DOMINION NUCLEAR CONNECTICUT, INC.
MILLSTONE POWER STATION UNIT 3
RESPONSE TO REQUEST FOR ADDITIONAL INFORMATION REGARDING
GENERIC LETTER (GL) 2004-02

MILLSTONE POWER STATION UNIT 3
RESPONSE TO REQUEST FOR ADDITIONAL INFORMATION REGARDING
GENERIC LETTER 2004-02

Millstone Power Station Unit 3 (MPS3) Head Loss and Vortexing RAI 6

Figure 1: Debris Bed Head Loss vs. Time for Test M3-C1

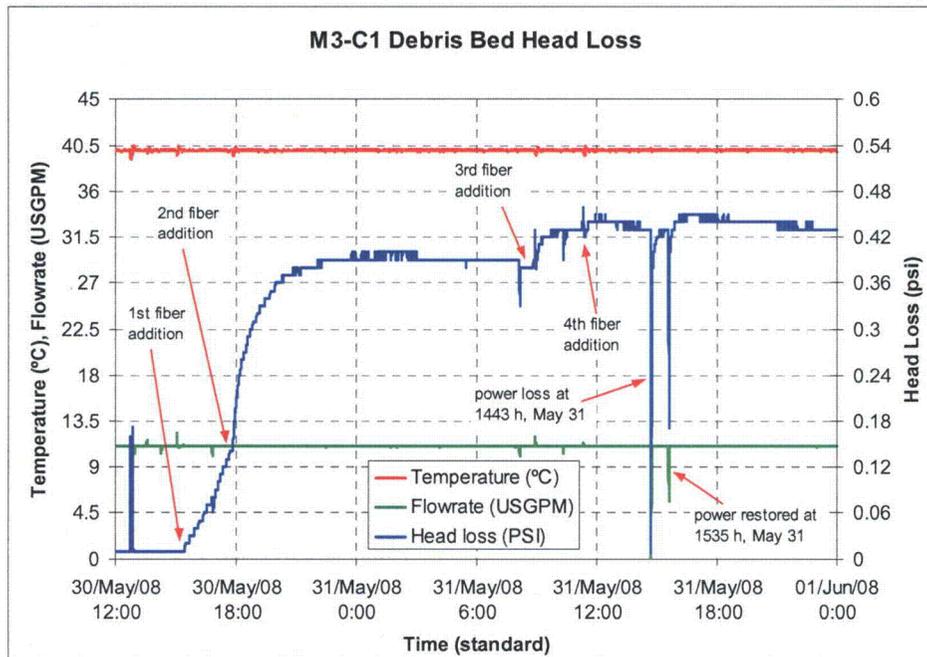
The December 18, 2008, DNC letter provides contradictory information on the amount of fibrous debris added during the test. On page 8, Attachment 2, it is stated that the limiting bed was determined to be 1/4 inch during earlier testing. Yet the same paragraph states that only two increments, containing fibrous debris to form 1/16 inch bed each, were added to the test and that no further fiber was added. Page 16 states that two 1/16 inch additions were made and implies that two further additions were made later. In addition, the graph on page 19 shows 4 fibrous additions. Describe, in detail, the initial fibrous debris conditions of the test and the amount of any additions that were made during the test.

The December 18, 2008, DNC letter states that the limiting thin bed for MPS3 is 1/4 inch as determined by previous testing. However, the head loss plot on page 19, Attachment 2, indicates that the third and fourth 1/16 inch fiber additions had little effect on head loss. Please evaluate the thin bed thickness for MPS3 in consideration of these points. Also, if the thin bed for the Rig-89 test is different from that of other tests that were used to provide Rig-89 test inputs, please provide an evaluation of how the final qualification test could have been affected by the use of such inputs. The licensee's assertion that 55% of the debris attached to the strainer for the Rig-89 test, and 72% and 84% attached to the strainer for the reduced scale test should also be considered in this evaluation.

For the MPS3 Rig 89 chemical effects test M3-C1, four fibrous debris additions were made to the test loop to achieve a thin bed thickness of 1/4 inch as determined by previous thin bed tests. The first fiber addition (1/16 in. (1.6 mm)) was made at 1504 h, May 30, 2008, after the addition of the particulate debris. The second fiber addition (an additional 1/16 in. (1.6 mm)) was made at 1750 h, May 30, 2008. The third and the fourth fiber additions (1/16 in. (1.6 mm)) were made at 0856 h and 1120 h, May 31, 2008, respectively. The detailed debris addition information is also indicated in the head loss vs. time curve as shown in Figure 1.

As shown in Figure 1 (response to RAI 6 Item 1), the debris bed head loss increased from 0.38 psi to 0.43 psi after the third fiber addition, indicating that the thin bed thickness was at least equivalent to three additions. After the fourth fiber addition, the head loss peaked at 0.45 psi and stabilized at 0.43 psi before the first chemical addition. This indicates that the fourth addition made little difference and the thin bed could be considered to be less than 1/4 inch.

Figure 3: Calcium Release Data from MPS3 Dissolution Tests without TSP at 90°C

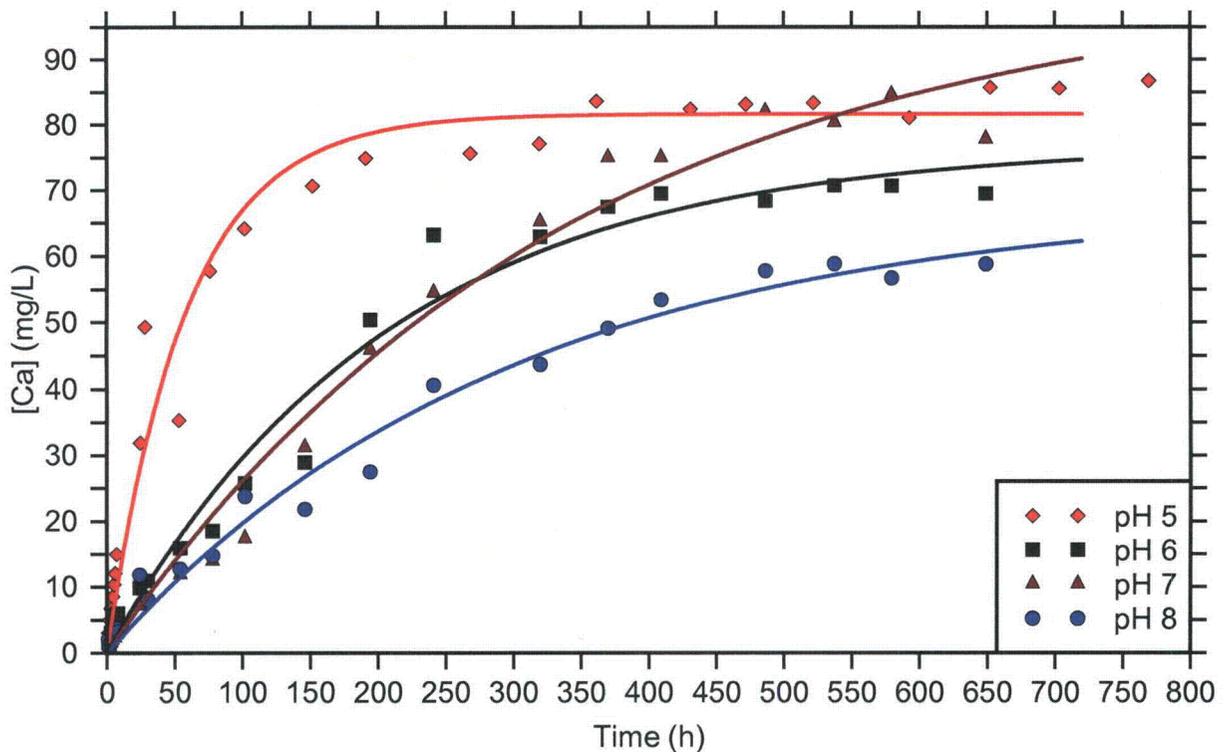
The solubility data for calcium shows increased dissolution at lower pH ranges. In table 0-2, Attachment 2, to the December 18, 2008 letter, the calcium concentrations for pH 5.0 and 6.0 are lower than the concentration for pH 7.0. In addition, page 11 of 30 states that the concrete samples in the beaker tests fully dissolved in the pH 5.0 and 6.0 tests but were not fully dissolved in the pH 7.0 and 8.0 tests. Please explain why the bench tests at lower pH ranges, in which the concrete fully dissolved, resulted in lower concentrations of dissolved calcium than the bench tests at higher pH ranges, in which the concrete did not fully dissolve.

The coupons used in these tests were small and subject to variability of rock and mortar content; thus, it must be argued that the coupons used in the pH 5 and 6 tests contained less mortar (the primary source of calcium) than those used in the pH 7 and 8 tests. The slightly lower concentrations attained in the pH 5 and 6 tests represented the limit of the calcium source (mortar) while slightly higher concentrations were attained in the pH 7 and 8 tests, despite the coupons remaining structurally intact. A more detailed explanation of the apparent conflict between the results of these tests and calcium solubility data is included below.

surface area-to-volume ratioⁱ do show higher dissolution rates at lower pH ranges, but the ultimate concentrations reached were lower in the tests at pH 5 and 6 than in those at pH 7 and 8 (Figure 3). This apparent contradiction can be explained by the small size of the coupons used: (each coupon measured approximately 0.4×1.2×0.5 cm, and were small in comparison to similar tests performed for MPS2). As a result of their limited size, two of the coupons completely dissolved in the pH 5 and 6 tests. Additionally, their small size made them more prone to containing non-uniform proportions of rock and mortar. Consequently, the calcium concentrations measured toward the end of the pH 5 and 6 tests represent the natural limit when all of the concrete had dissolved. The data from all of the tests were fit to Equation 1. The early plateau seen in Figure 3 for the pH 5 and 6 tests biased their extrapolated concentrations at t=∞ shown in Table 1 (Table O-2 of the above-mentioned report).

The recovery of coupons from the pH 7 and 8 tests, and the lack of any obvious plateau in Figure 3, strongly implies that the results of these more important tests were not biased by a limited calcium source. The results of the pH 7 test, in particular, were used in the design of the reduced-scale test, as pH 7 is the minimum allowed sump water pH. However, it should be noted that this remains a conservative estimate of calcium release since the MPS3 sump pool is likely to remain mainly above pH 8.

Figure 4: Calcium Release Data from MPS3 pH 7 and pH 8 Dissolution Tests
(without Tri-Sodium Phosphate (TSP)) @ 90°C

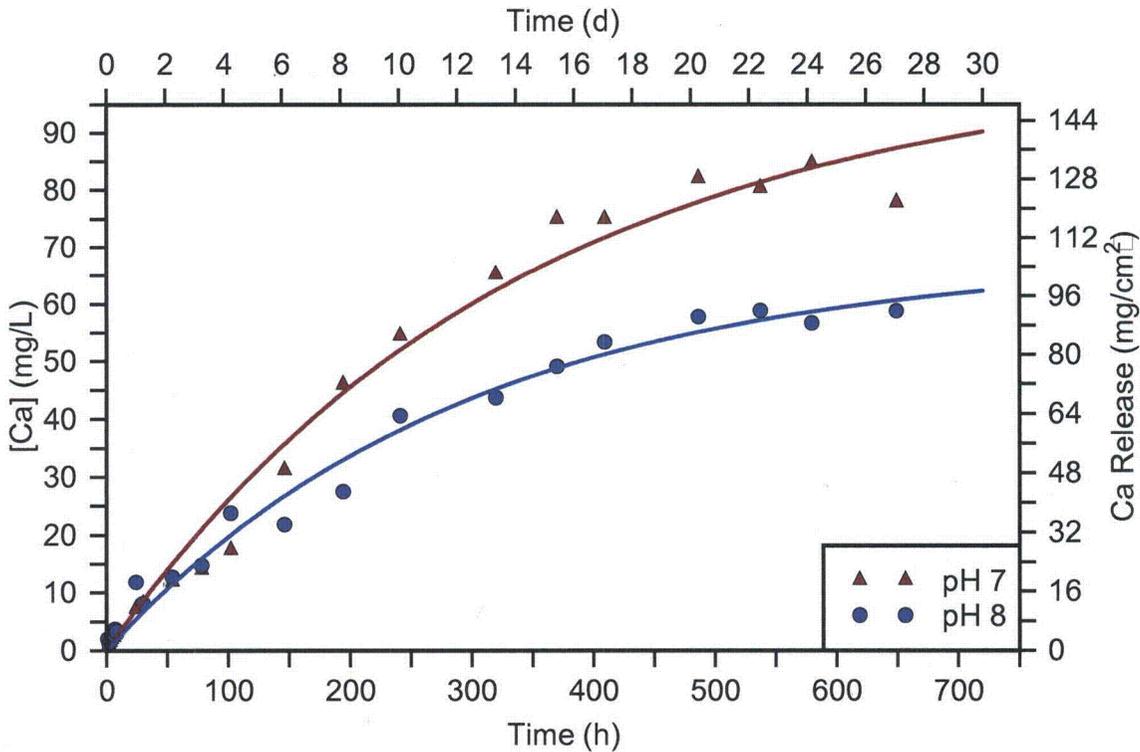
For MPS3, the calcium dissolution test at pH of 7.0 resulted in a 30-day calcium concentration of 78 mg/L. The December 18, 2008, letter states that the pH 7.0 case (without TSP present) was used to determine the concentration of calcium in the Rig-B9 test. However, the calcium concentration used for Rig-89 testing was 14.7 mg/L. Please justify why 14.7 mg/L is a representative value in the Rig-89 testing when the dissolution testing conducted with scaled quantities of concrete resulted in a calcium concentration of 78 mg/L.

The concrete surface area-to-volume (SA/V) ratio used in the bench-top dissolution tests was roughly six times greater than the current calculated SA/V ratio using data from ERC 25212-ER-06-0013 Rev. 2 [2] and leads to the apparent discrepancy. The dissolution tests conducted from February to March, 2008, used coupons sized to meet the SA/V ratio calculated from Rev. 1 of ERC 25212-ER-06-0013 [4] and included scaled quantities of fibrous debris. Table 2 compares the SA/V ratio used in the dissolution tests to those calculated from the source references. It is important to note that, by design, there is no uncoated concrete within the MPS3 containment and that all values quoted are conservative estimates of bare areas exposed either by chipping and wear or by impact of the break jet [2].

Because the concrete SA/V ratio for containment differs from that tested, the results obtained are non-representative but may be appropriately scaled. Normalization of the dissolution test data may be performed by dividing the results (in mg/L) by the SA/V ratio (0.64 cm²/L), as indicated by the right-hand vertical axis in Figure 4. Similarly, the fit to the calcium concentration data described below, may also be normalized to produce a calcium release equation. Thus, the 30-day calcium release per unit area of concrete can be read from the figure or calculated from the fit and used to calculate the calcium release from a known surface area of concrete.

Figure 4 also shows the curve fits to the data represented by Equations 2 and 3. These were determined using robust fitting procedures within TableCurve 2D[†] that reduce the fitting errors caused by data outliers. The constants found within Equation 2 were reported in Table 2-5 of the bench-top test report [3] and Table O-2 of DNC's December 18, 2008 letter. Equation 3 may be calculated from Equation 2 by dividing the initial constantⁱⁱ by the tested surface area-to-volume ratio, 0.64 cm²/L.

Figure 6: 3D Illustration of the WCAP Aluminum Release Model

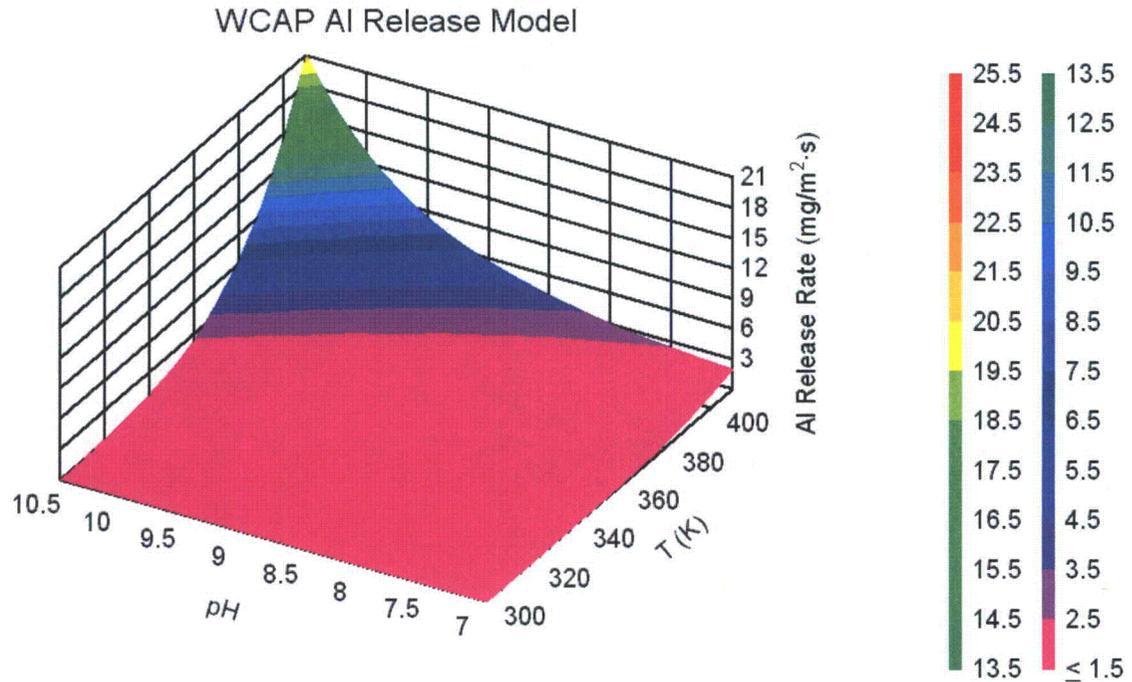
Please compare the total amount of aluminum that is predicted to be released by the AECL model with that predicted by the WCAP-16530 base model (i.e., no refinements for silicate or phosphate inhibition). Discuss any significant differences between the plant-specific predictions for the two methods, including the acceptability of these differences.

The WCAP-16530 base model is an empirical model of the aluminum release rate (RR) based on the data set described by Lane et al [5], which included data from ICET 1, CR-6873, WCAP-7153A and WCAP-16530. The WCAP model is described by Equation 4 and the results are shown in Figure 6.
